PSTA Preliminary Plan No. 120200100 and Mandatory Referral No. MR2021030

Description

Request to subdivide Montgomery County's former Public Safety Training Academy (PSTA) site that was vacated in 2016, into 290 buildable lots and 35 parcels for the future construction of 630 residential units, commercial use, public open space, HOA parcels, and roads. This Preliminary Plan is associated with Mandatory Referral No. MR2021030 for disposition of County-owned land.

Figure 7: Proposed Street A and B Cross Section

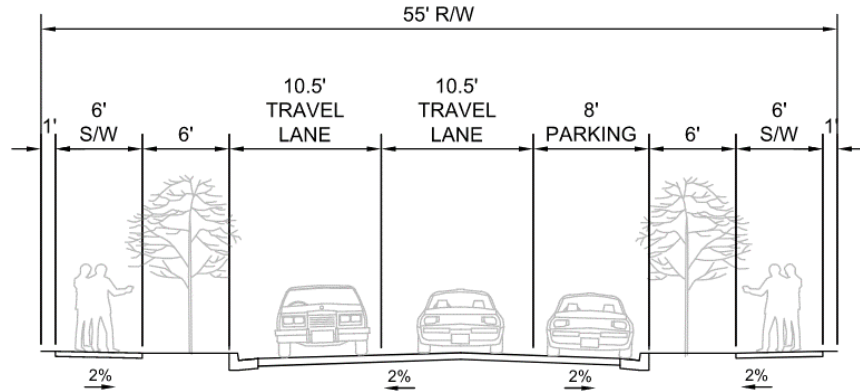
- e) Include the construction phasing drawing within the Certified Preliminary Plan set.
 - f) Revise the Street A and Street B transition at Blackwell Road that shows Street A terminating into parallel parking as follows:

- i. Remove 36'x18' of the parallel parking spaces on each side of the parking entrance in the multi-family apartment building parking lot at the terminus of Street A.

- ii. Remove approximately 18' x 18' of the parking on each side of the parking lot at the terminus of Street B.
 - iii. Replace the parking with a vegetated area of grass and trees for screening and a physical transition from the street to the parking to signify the prominence of Street A in relation to Street B.

Figure 12: Applicant's Proposed Medical Center Drive Cross-Section with Inset of MCDOT/M-NCPPC's Requested Cross-Section

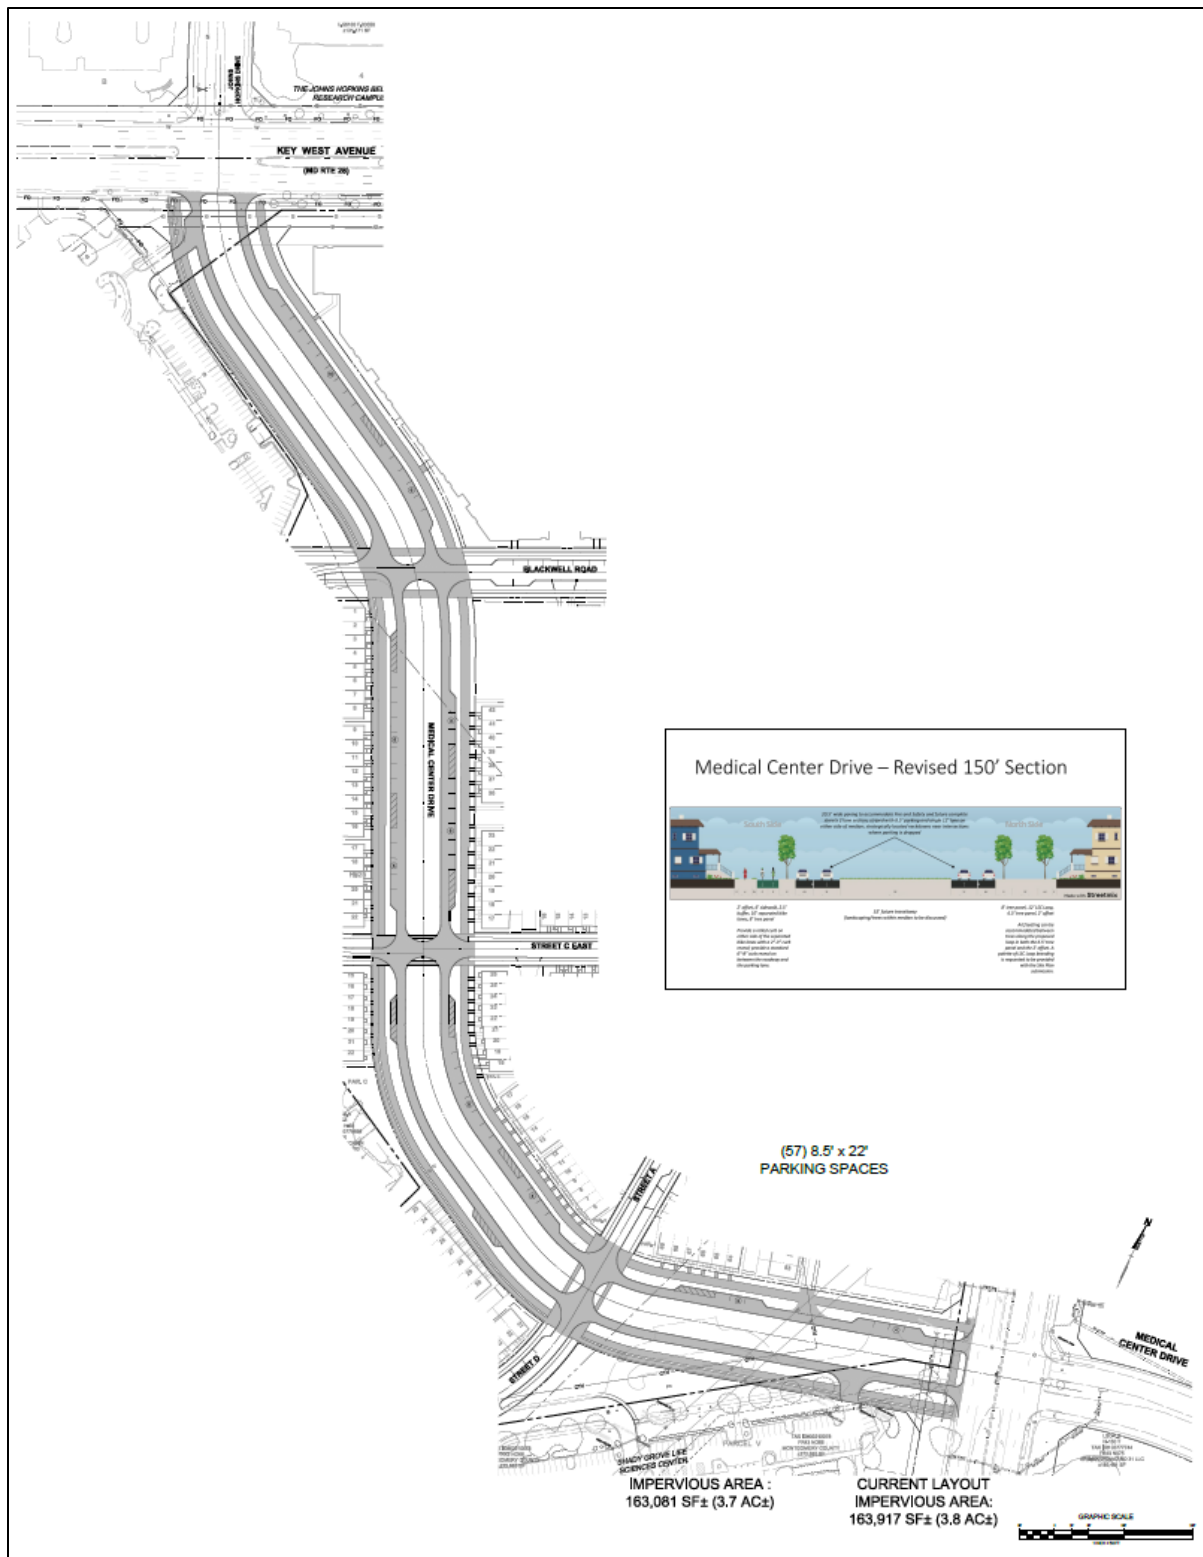
Currently, there are right-of-way limitations due to ownership to the road construction. The segment of Medical Center Drive between Blackwell Road and Key West Avenue is proposed to be built when the right-of-way from 9850 Key West Avenue is acquired. However, this segment will have limited access to Fire and Rescue Services, pedestrians, and cyclists until the connection to Key West Avenue is complete and open to vehicular traffic.

- e) Street D with 59-foot right-of-way
 - f) Blackwell Road with 73-foot right-of-way
26. The Applicant must dedicate 150-foot-right-of-way for Medical Center Drive and will design and construct all necessary improvements as shown in the Medical Center Drive road cross-section on the Certified Preliminary Plan.
